**Letter to Sandra Tucker, U.S. Fish and Wildlife Service from Paul A. Conrad, USGS dated April 13, 2009**

SAVANNAH HARBOR  
REOXYGENATION DEMONSTRATION  
PROJECT  
GEORGIA PORTS AUTHORITY  
SAVANNAH, GEORGIA

Figure: C.1

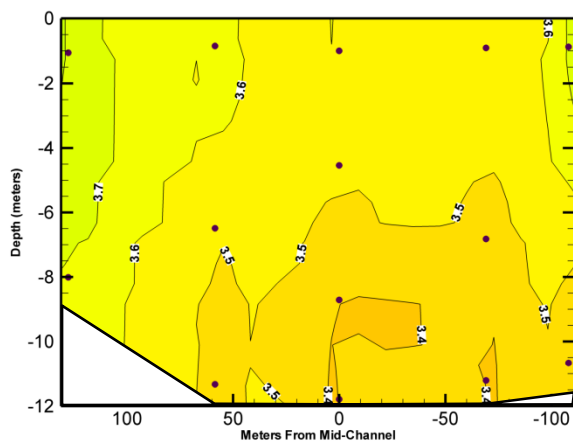
5. *The conclusion of the signal-to-noise analysis is that the effect of the ReOx system on the near shore DO cannot be reliably separated from the DO measurements. If this analysis was done for other cells in the model, could it provide some guidance for designing an effective data-collection network? An “effect size” analysis was done and it was concluded that the variability of the DO data would mask the small effect ReOx system because the standard deviation of the measured data and the mean of the expected effect were of the same order of magnitude. Would the standard deviations also be of the same order of magnitude for other locations in the river and not only the near shore? If so, would it indicate that the effect of the ReOx system could not be measured? What are the implications for the profiling and transect data? What are the implications for the recommendation “...to monitor the effects to water quality in an adaptive management approach”?*

For purposes of this analysis, the relative DO “effect size” at a particular location is the dimensionless ratio of the average DO increase (mg/L) attributed to supplemental oxygenation at that location divided by the standard deviation of the DO (mg/L) at that location over the demonstration period. As the effect size decreases, it becomes increasingly more difficult to independently discern or “tease out” the supplemental DO effect from the baseline DO variability of a continuous data set.

Given the nature of adding supplemental oxygen to a highly dynamic tidal system like Savannah harbor, there is no upstream control point available for baseline DO monitoring as might otherwise be the case for a free-flowing non-tidal river. However, the Savannah Harbor DO modeling results for the simulated ReOx demonstration period do show how the DO effect size varied as a function of relative position in the river cross section. Figure C.1 shows the model-simulated average (50<sup>th</sup> percentile) DO increase from supplemental oxygenation, the simulated DO standard deviation, and the resulting simulated effect-size ratio in each of the 11 model cross-section cells; five main channel cells flanked on each side by three overbank cells. As expected, the largest simulated delta DO (0.62 mg/l) is in the deep main channel cell where the oxygen was added and the smallest simulated delta DO (less than 0.2 mg/L) is in the shallow surface cells.

Figure: C.4

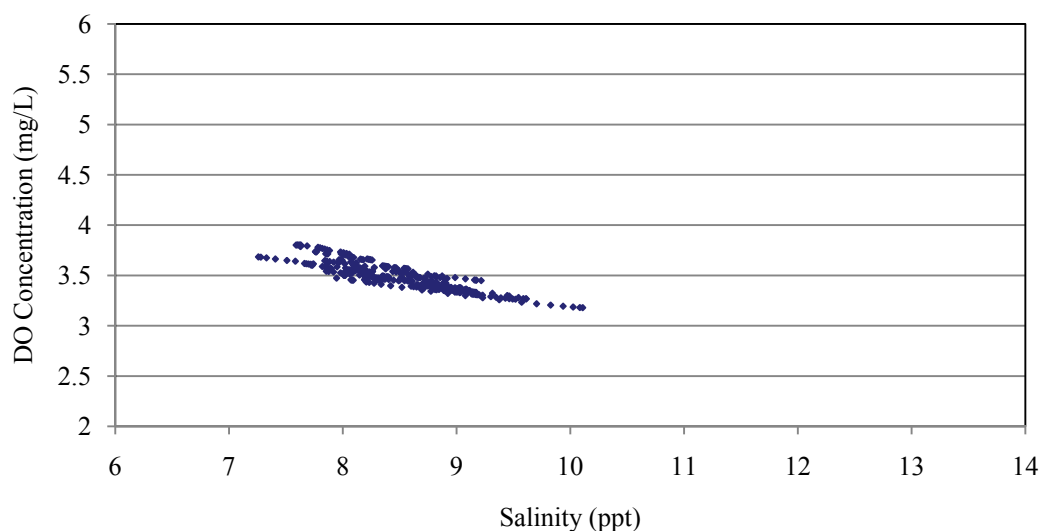
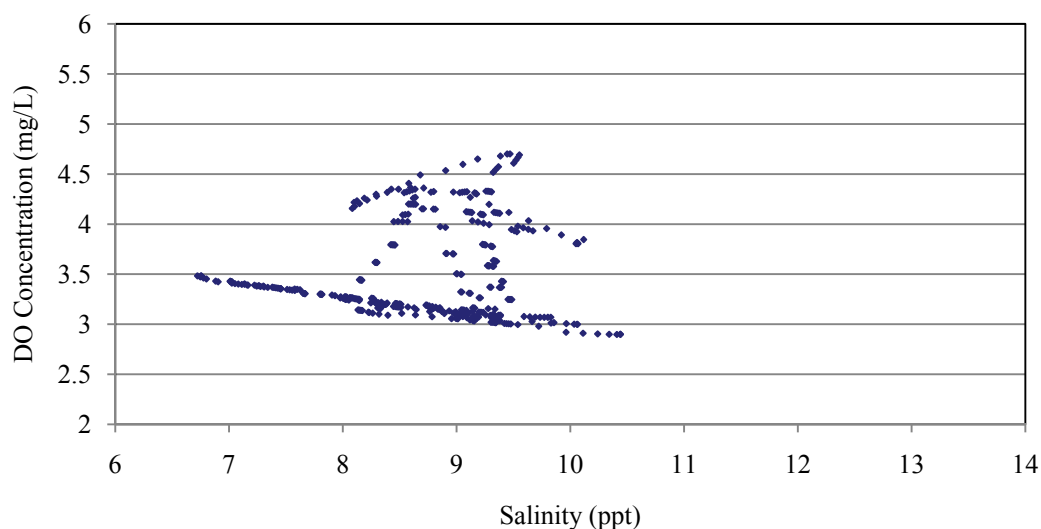
9. *The river transect plots do show gradients across the channel. Although the gradients are larger during the operation of the ReOx system (fig. 3.25), mild gradients across the channel can also be seen in some of the transects before the operation of the ReOx system (figs. 3.23 and 3.24). Although the gradients provide some evidence of the influence of the ReOx demonstration project, it is only anecdotal evidence. A quantification of the amount of the transect variability that is natural and the amount that is attributable to the ReOx system is not provided. Plots of the salinity distributions for the transects would have been helpful, as was done with the mid-channel low-tide profiles, to see if any of the DO gradients are attributable to salinity gradients.*

Fourteen measured dissolved oxygen and salinity concentrations from Transect 2 before (8/7/2007) and after (8/10/2007) oxygen injection were imported into Tecplot 10 and interpolated into a grid of 400 data points using inverse distance interpolation. This interpolation method generates values on a regular grid from a weighted average of nearby points. Being an average, this method does not necessarily produce the actual data value where sample locations and grid points are co-located. In addition, there is some smoothing of the original data so that grid minimum and maximum values may not be as large or small as the original data. The interpolated DO concentrations were plotted against interpolated salinity before and after injection (Figure C.4). Before injection, a linear relationship exists between dissolved oxygen and salinity representing very little disturbance to the river. After injection, a disturbance has been created between the relationship of DO and salinity due to increased DO concentrations. Figures C.2 and C.3 also compare DO concentration and salinity before and after oxygen was added to the system. Salinity and DO patterns before oxygen injection are similar on 7/10/2007 and 8/7/2007. During injection, salinity patterns remain similar while DO patterns differ as shown Figures C.2 and C.3 for low and high tides, respectfully, suggesting a disturbance in the system caused by the ReOx injection system. After the injected oxygen was shutdown on 9/16/2007, the low and high tide transects just upstream of the injection location return to similar patterns as prior to the injection period.
